Re: Interpretation for PCA/FDPA 87-P-052-2 and PCA/FDPA 84-P-007-3, Centerpointe III; Tax Map 46-3 ((1)) 40, 51: Retaining Wall and Pump Facility

**Re: Centerpointe III, PCA 84-P-007, PCA 87-P-052
Tax Map No. 46-3-((1))-40, 51
Interpretation Request**

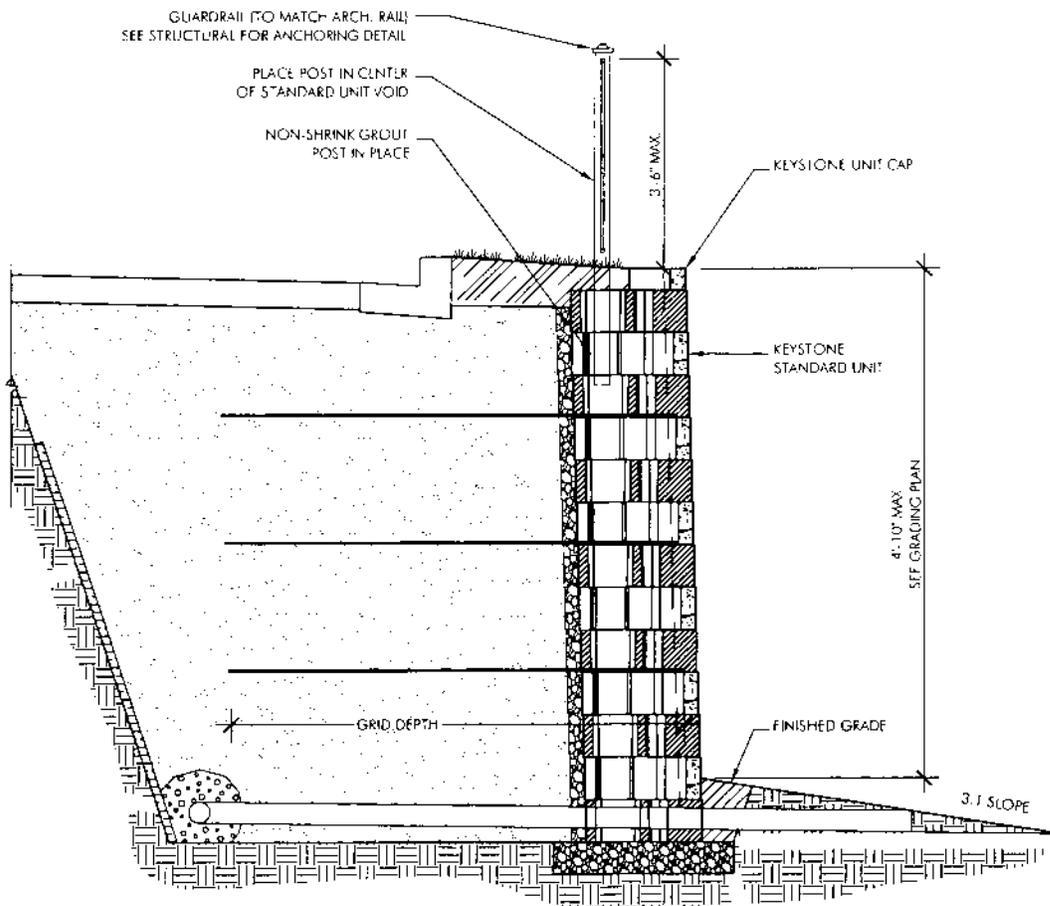
The first modification is to add a retaining wall adjacent to units 24 and 25 as shown on the attached sketch. This wall allows for alley B to be raised resulting in an improved grading condition in the courtyard area between units 25-34. The proposed wall will be a maximum of 4'-10" in height and will be constructed in accordance with proffer 20 as shown on the attached detail. The wall will have limited visibility and will face the parking garage on the adjacent off-site property.

It is my determination that construction of the retaining wall and the addition of a pump room to the townhouse unit on Lot 85, as described above, are in substantial conformance with the proffers, the CDPA/FDPA and development conditions.

KEYSTONE SEGMENTED BLOCK RETAINING WALL

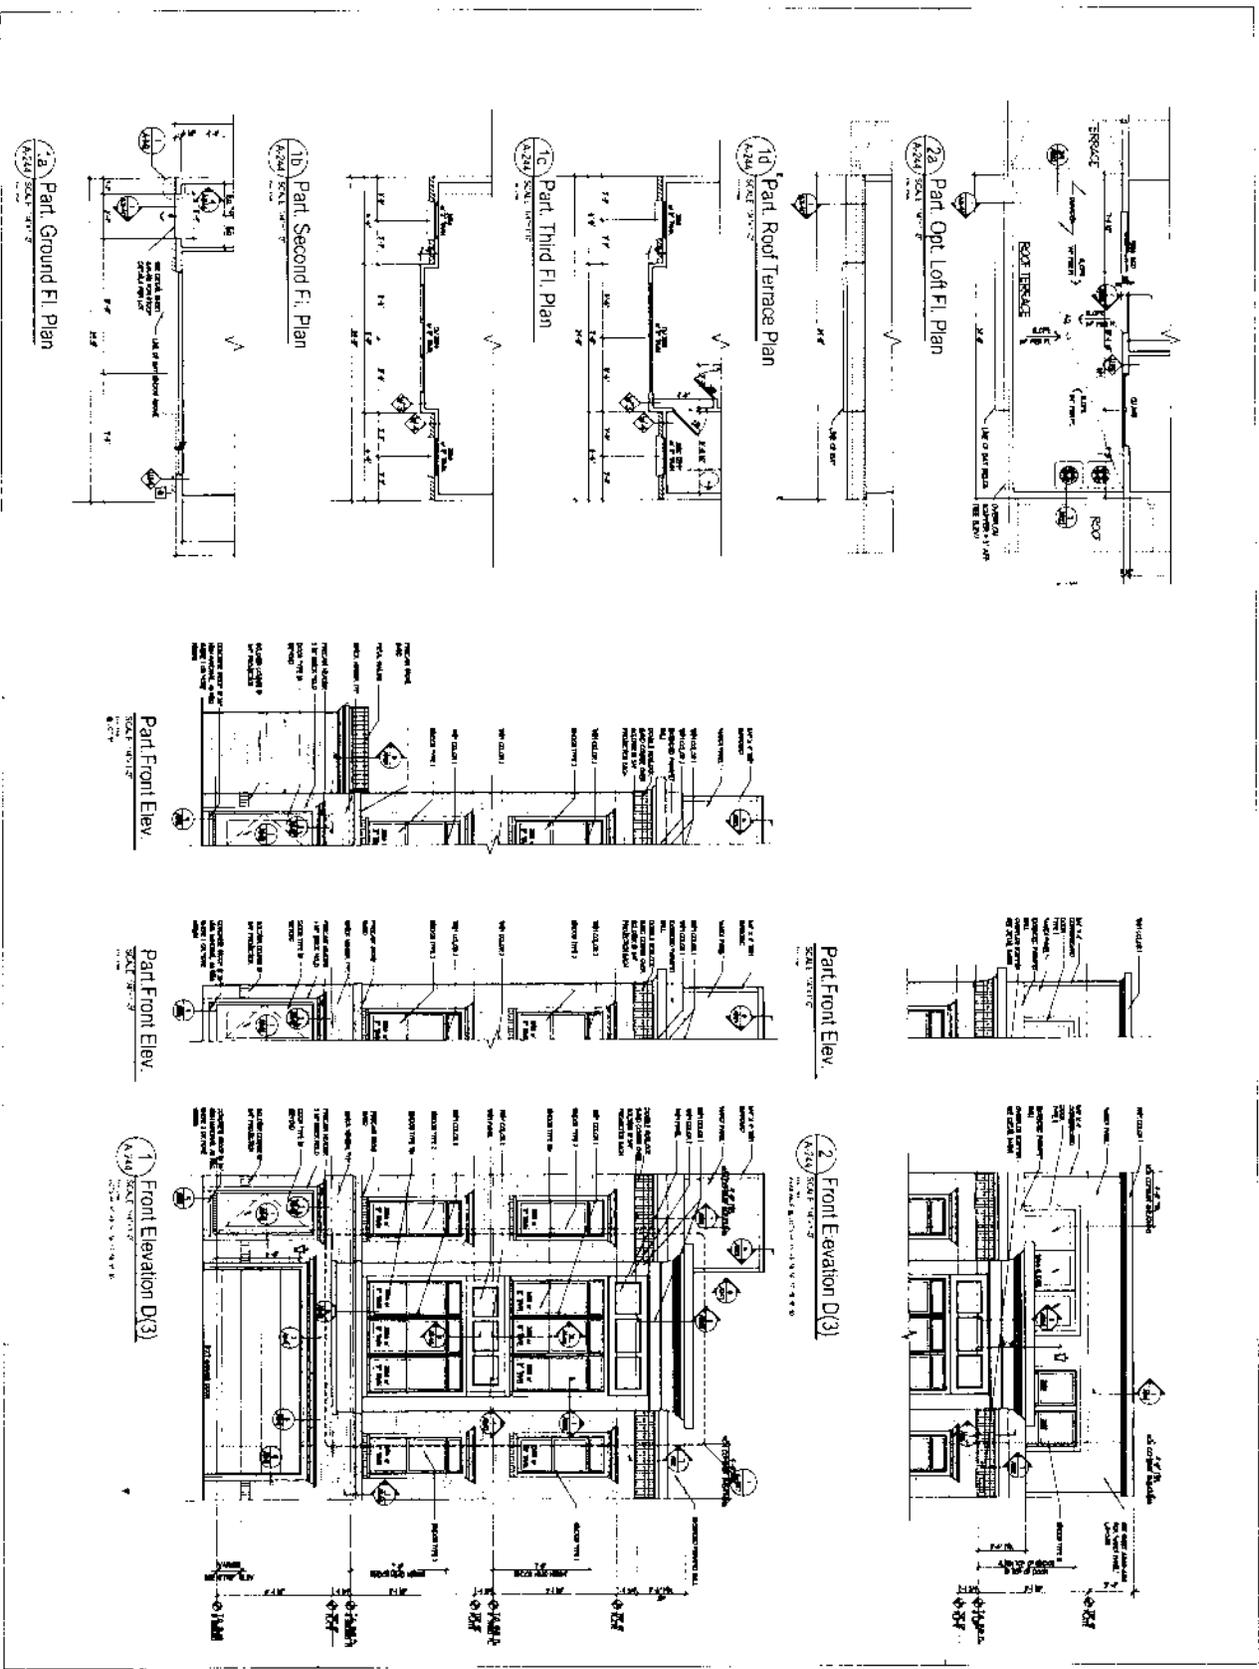
As I understand it, the first question is whether a retaining wall, not shown on the approved CDPA/FDPA, may be constructed adjacent to units 24 and 25 in the southwest portion of the subject property. The purpose of the retaining wall is to address grading conditions between the alley and courtyard areas of units 20-34. The letter states that the wall will be constructed with a maximum height of 4 ft. 10 in. and in accordance with Proffer 20 for design and materials, as illustrated in the submitted elevations. Proffer 20 states: *Retaining walls...as may be required at the time of final site plan design, shall be constructed either with keystone blocks or with concrete faced with masonry to ensure an aesthetically pleasing appearance...* The submitted elevations indicate the wall will be constructed of keystone blocks.

LOT 85 - D(3) REV

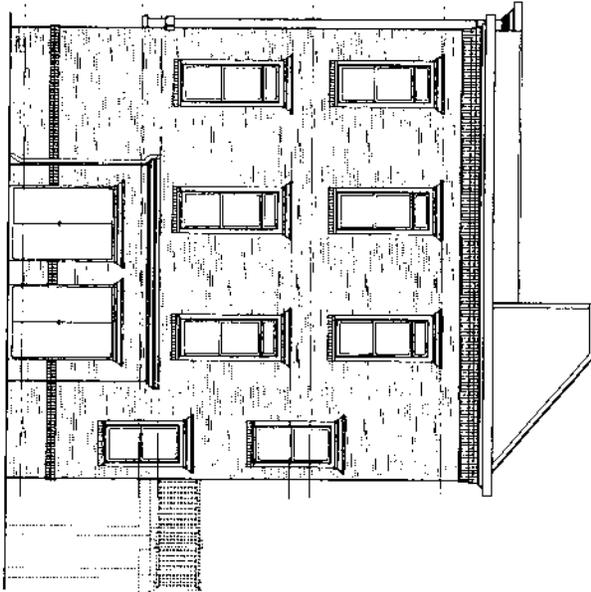
The second question is whether a pump room, not shown on the approved CDPA/FDPA, may be added on the side of a townhouse unit on Lot 85 in the east portion of the subject property to house the required fire suppression system for the town house buildings. You have indicated that the location and design of the pump room has been approved by the Fairfax County Fire Marshal and Fairfax Water. The pump room, as shown on the submitted layout, is approximately 96 sq. ft. and will be constructed of exterior materials to match the exterior of the town house units. The proposed exterior doors and rooftop railing will be consistent with the elevations dated December 22, 2006.

The second modification is to add a pump room to serve the fire sprinkler system in the townhome units as shown on the attached drawings. The pump system protects the community and is required for the fire suppression system to deliver adequate pressure to the fourth floor levels of all the attached units during an emergency situation. The pumps will serve all the town home buildings and have been located adjacent to unit 85 which is the first stick planned for development. This location and design has been approved by the Fairfax County Fire Marshall and Fairfax Water. The pump system must be accessible for regular inspections and requires a room with interior dimensions of 14' X 5'. A plan view and elevation of unit 85 is attached. As suggested in our preliminary
